BID ADDENDUM NO. 1  
April 18, 2019

## Town of Mansfield, Connecticut Southeast Park Well Installation

PROPOSED SEPTIC SYSTEM FOR  
SOUTHEAST FIELDS CONCESSION BUILDING

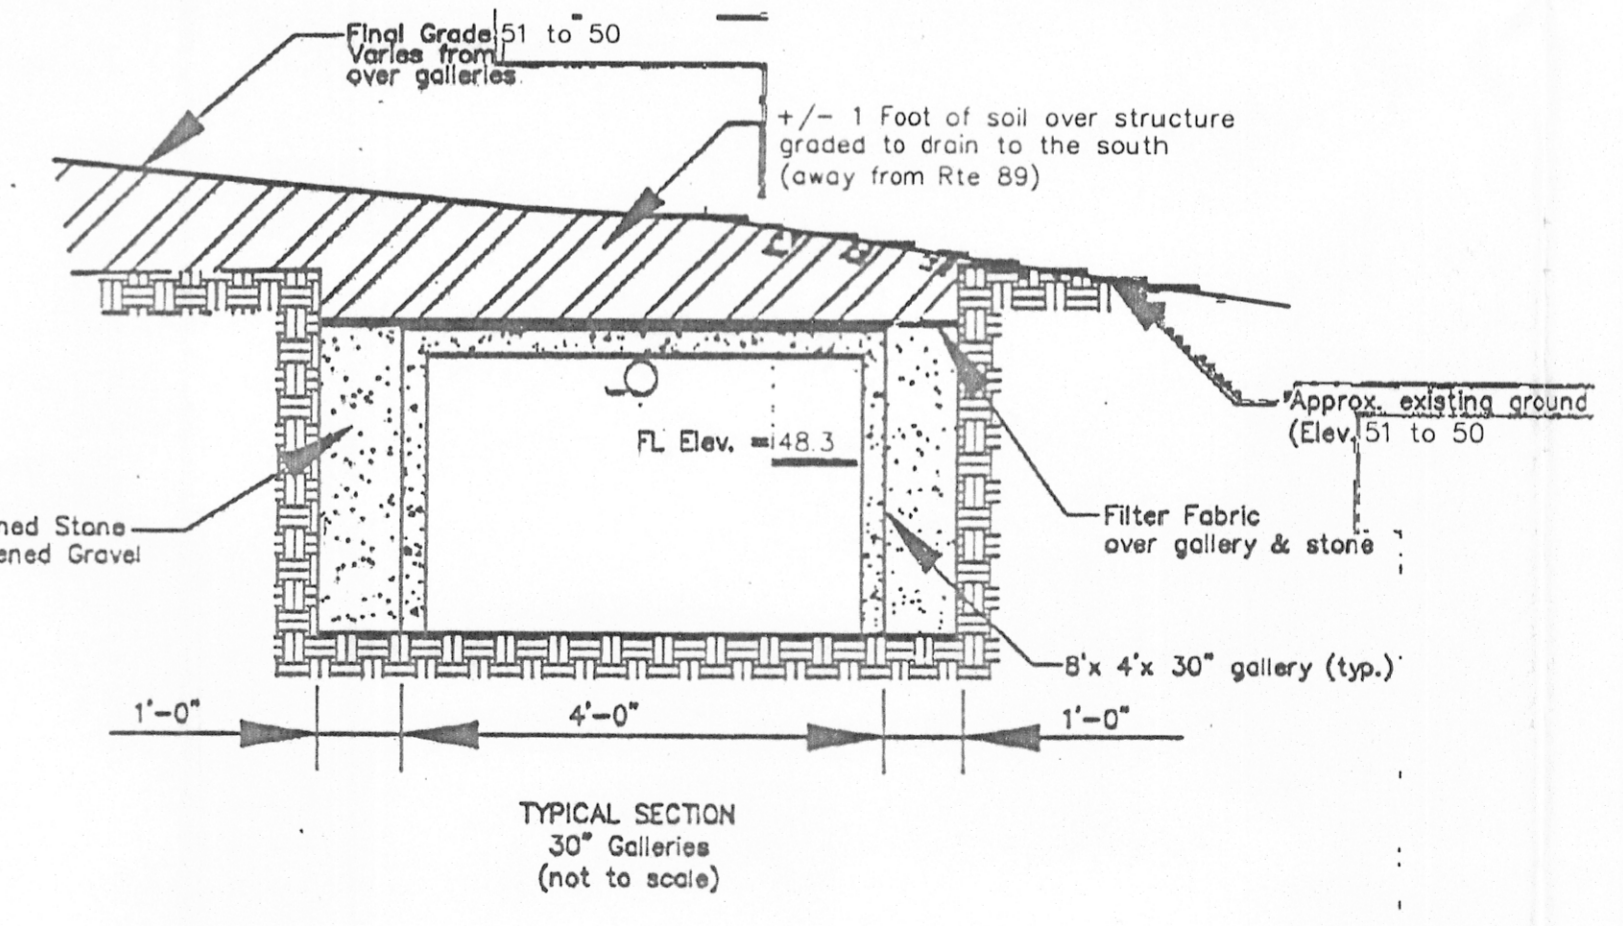
Q1: Are there any plans showing where the underground electric runs are located?

**A1: Please see Attachment B for the design plan and septic as built tank locations.**
